ON-SITE SEWAGE DISPOSAL SYSTEM HOWARD COUNTY HEALTH DEPARTMENT BUREAU OF ENVIRONMENTAL HEALTH

SUBDIVISION: New Horizon Farm LOT NUMBER: 1

FILE INQUIRY NOTES

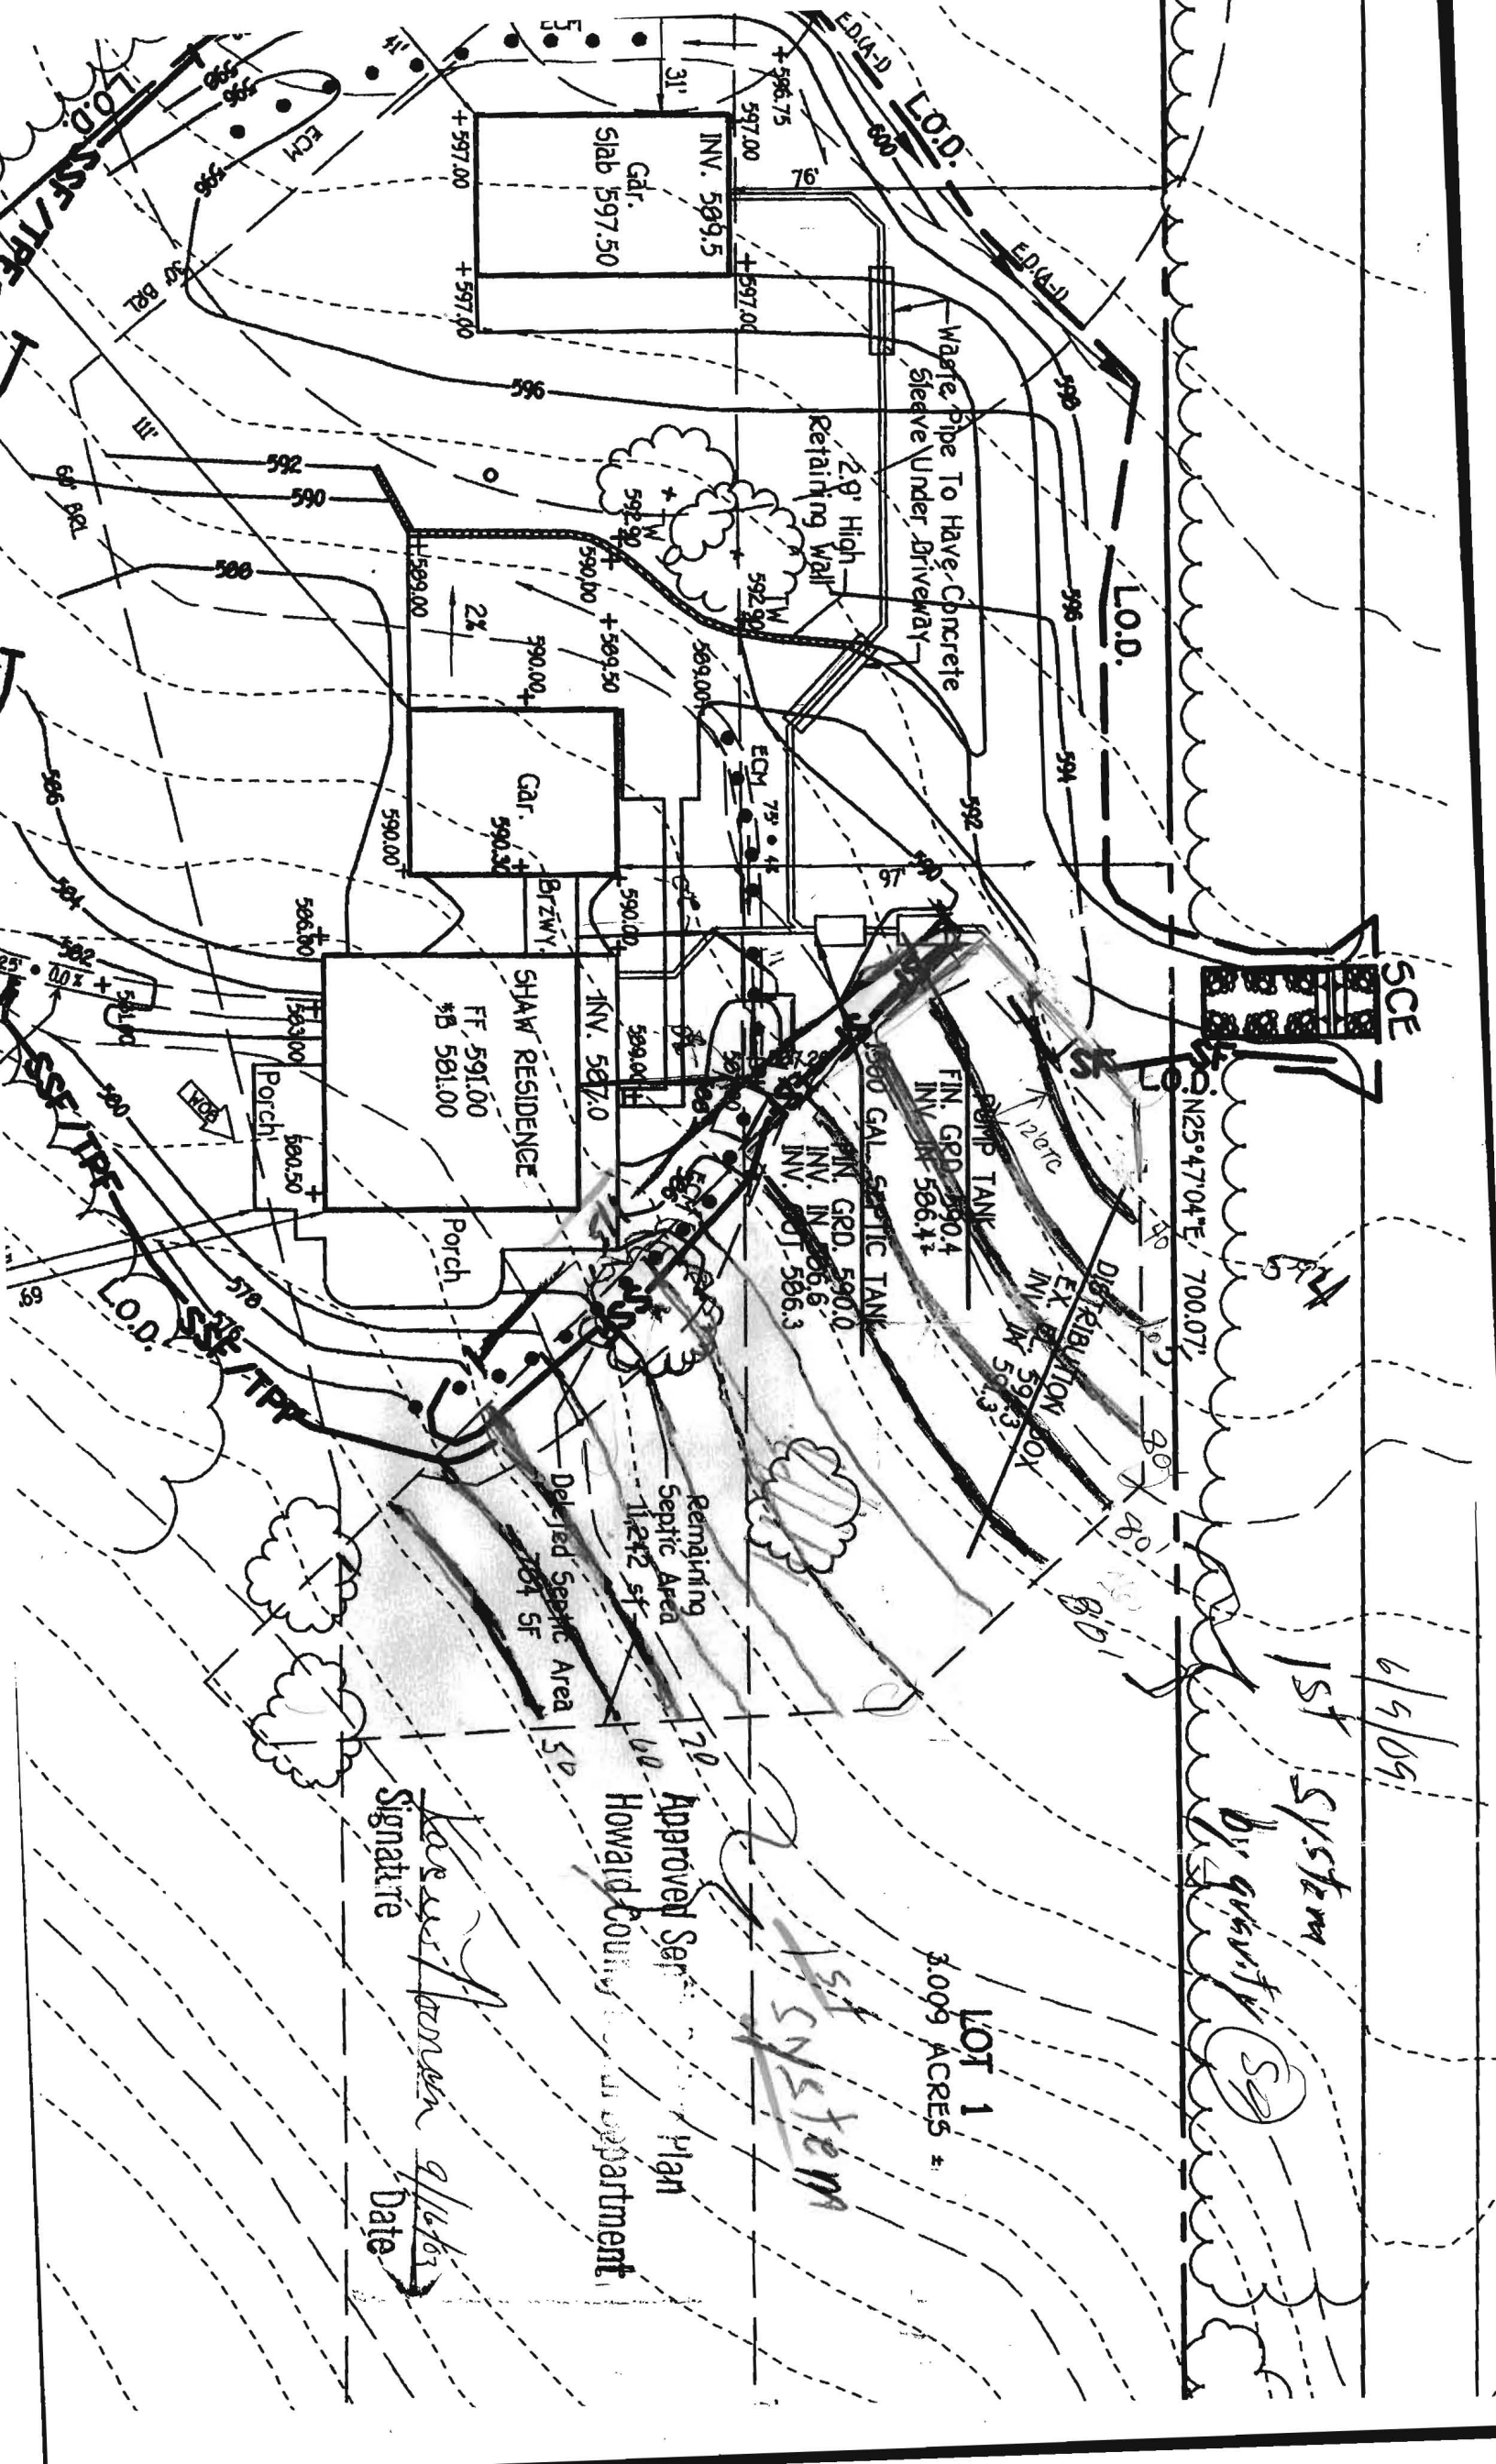
7/13/09 Landon Smith, installer, calls to inquire about Health Dept requirement to install pump tank and a gravity flow drainfield system.

7/14/09 Property owner Jon Shaw, at Bureau desk, appeals that requirement to pump to upper portion of drainfield is counter to his philosophy to personally minimize energy usage.

Among issues identified during conversation were:

- Wrong Application Rate
- Trench bottom incorrect for lower portion of easement
- Effective Sidewall generally unknown, very sketchy profile descriptions

PB I explained that it is Health Dept policy to install trenches in highest portion of septic easement for the initial system. If a pump tank is required, then it will be installed and utilized. Also expressed that I do not know the reason that the issued permit has specifications that vary from policy.

PB, I explained to owner that these concerns would be reconciled at layout Inspection. The installation inspector will take into account the specifications on the issued permit, especially in regard to elevations and soil characteristics. It is the inspectors prerogative to require testing so a system can be properly design.

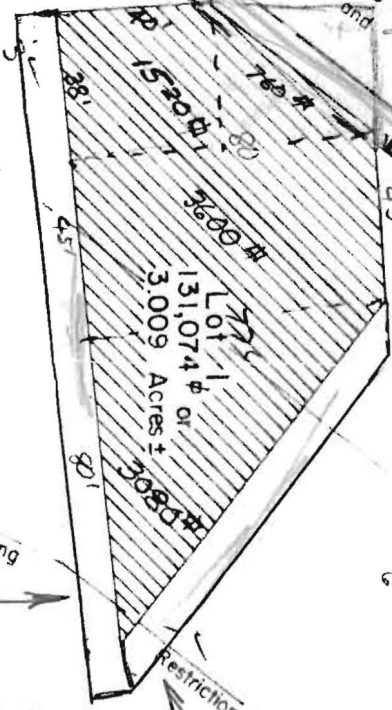
Failed 31' OK 7 1/2
4 1/2
5 1/2
VILLI LOOKS OK

ADD 10' TO EACH SIDE
TO HAVE MIN 10,000 #

will lose an additional 4' 3" along R/W
